# TECHNICAL SERVICE BULLETIN

## **G5000 CRADLE RETRO FIT SLIDE-OUT AWNING SYSTEM**

### **INSTRUCTIONS FOR 2 FOOT CRADLE RETRO FIT**

### **GIRARD REPLACEMENT KIT #1511113-03K**

## DIAGRAM 7

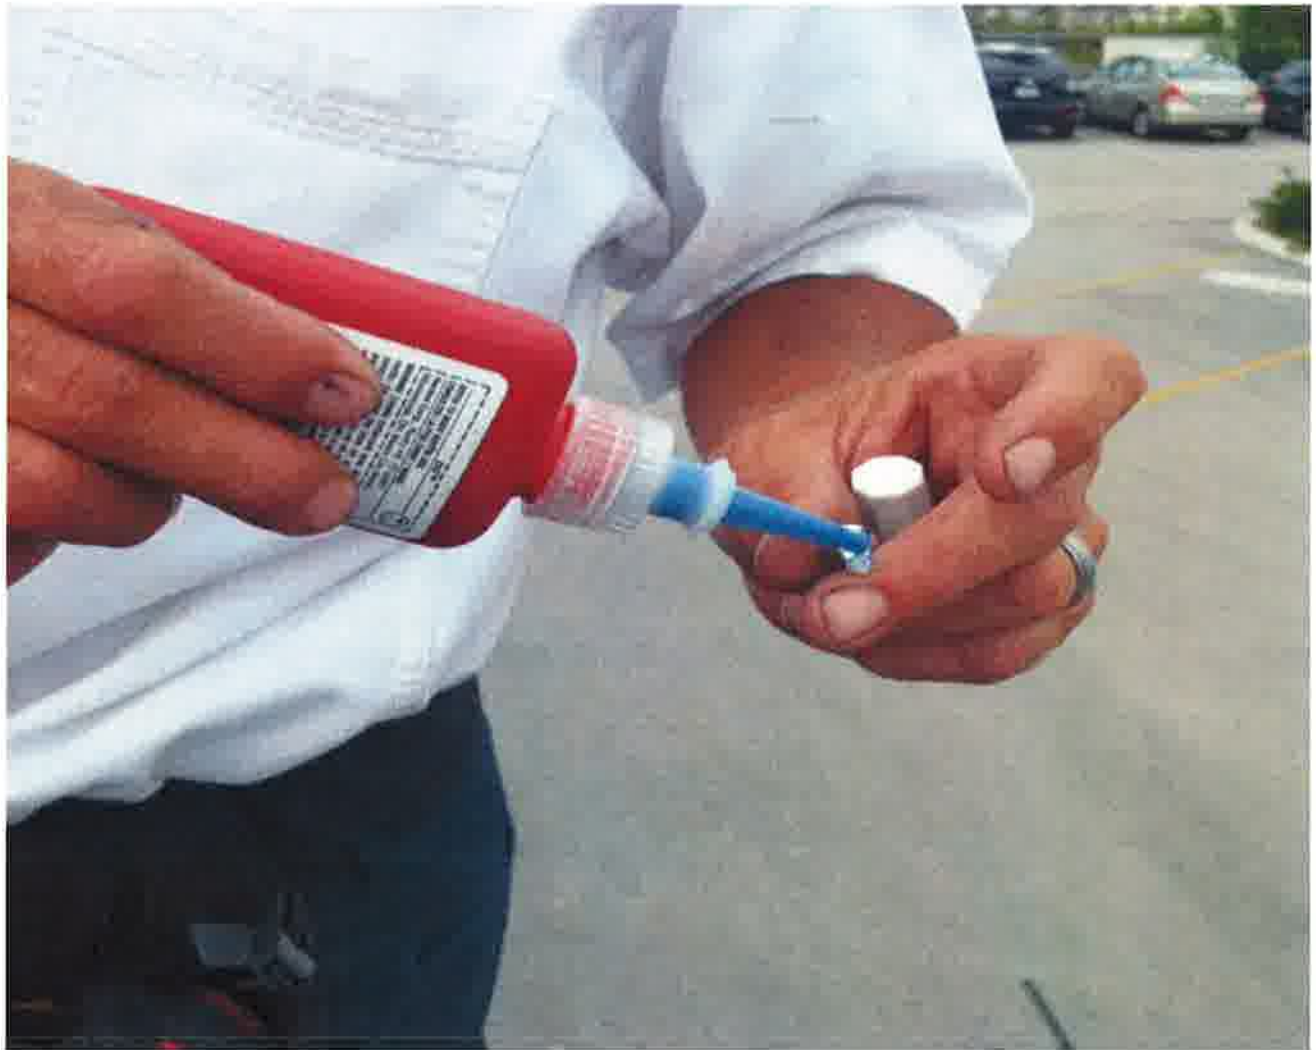
Remove cradle from frame.
